HISTORIC LANDMARK COMMISSION

Graylynn Apartments Window Replacement PLNHLC2010-00311 205 2nd Avenue August 4, 2010

Sunview Series Vinyl Frame Window

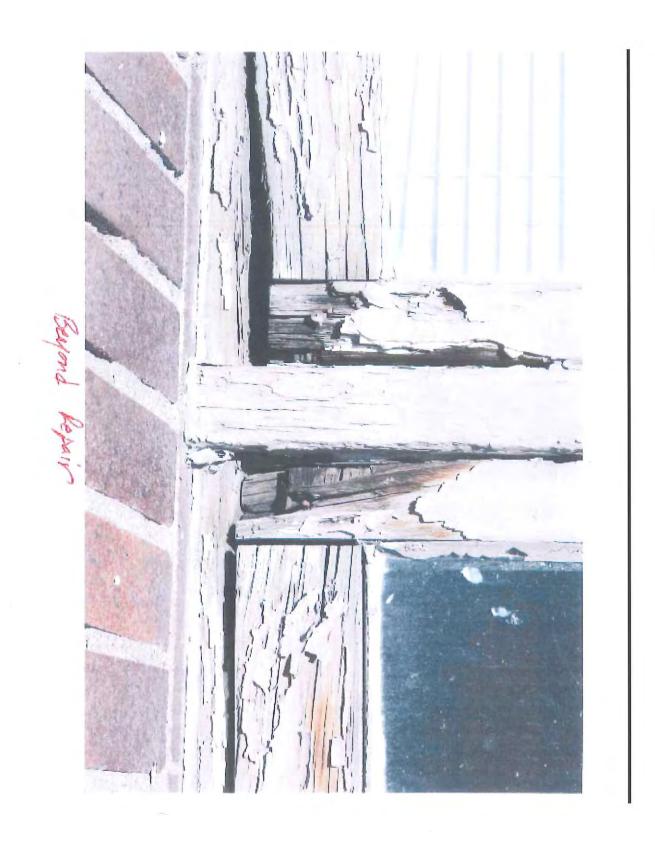
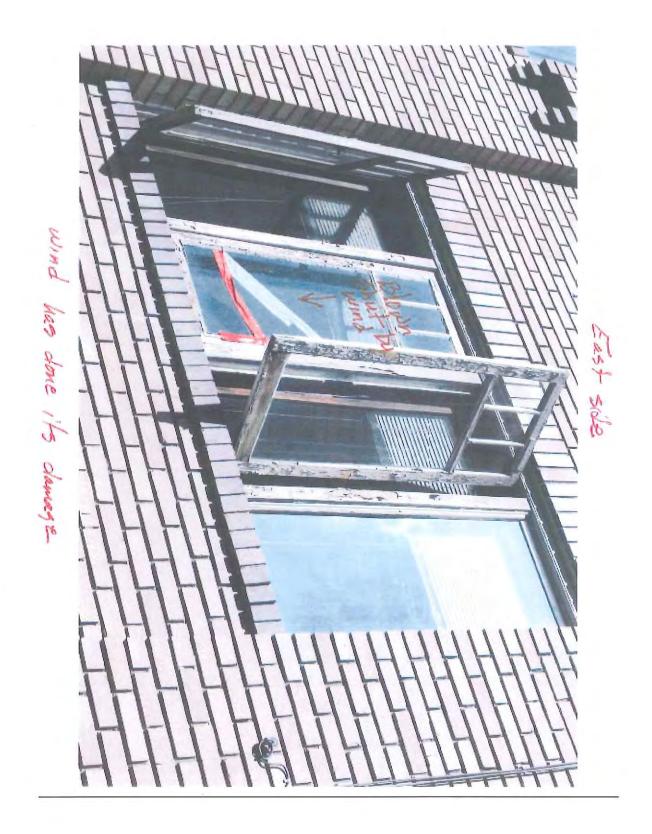
The replacement window proposed is a vinyl slider style window that would be painted to match the trim color of the original windows. The windows are double paned with false muntins between the panes to match the original style (see photos exhibit B). The Historic District Design Guidelines state that the installation of vinyl windows should be reviewed on a case by case basis, requiring approval by the HLC. Normally, window replacements are reviewed administratively and only rise to the level of the Commission in the case of an appeal of an administrative action.

Planning Staff asserts that the primary issue with the proposed slider windows is that they do not appropriately replicate the muntins of the originals. Typically, a more substantial muntin would separate side-by-side windows of this nature. This window grid pattern is an important feature in the architecture of the building. An internal grid (sandwiched between the double panes of glass) has been installed on the existing vinyl windows. Planning Staff finds that this internal system is not consistent with the historic characteristics of the windows that are proposed to be replaced. Therefore, the grids should be removed from the newly replaced windows, and substantial exterior muntins should be installed on the replacement windows. Internal grid patterns are never appropriate for windows on the primary façade (and perhaps secondary or rear facades) for structures in the City's historic districts, nor have they ever been approved.

Analysis: The vinyl windows chosen to replace the existing wood windows generally meet the design criteria for replacement windows (with the exception of the muntins discussed above). The style is similar to the originals, and the profile of the windows generally meets the criteria as well. The applicant is proposing to retain the original casing of the window and to retain the original glazing pattern of the windows.

1. The new windows (including those installed without a building permit) shall have significant exterior muntins installed with the same design as the muntins on the original windows.

2. Prior to the issue of a building permit, the applicant shall bring examples of the muntins to staff for review and approval.

East Sid

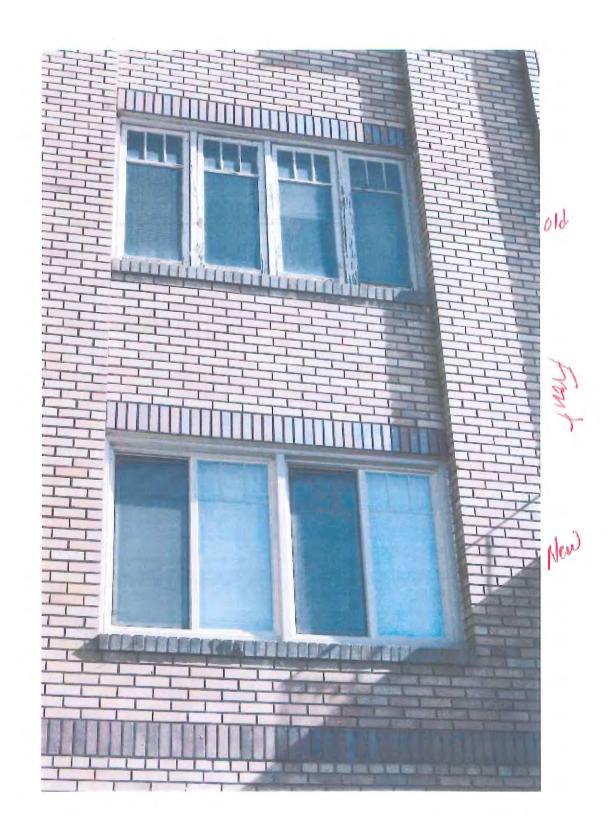
Analysis: A majority of the remaining windows are original. They are however, in poor repair. The applicant states that the majority do not properly operate, are broken, or have been modified

significantly and as such, many have been nailed shut so that they do not fallout of place (see photos exhibit B).
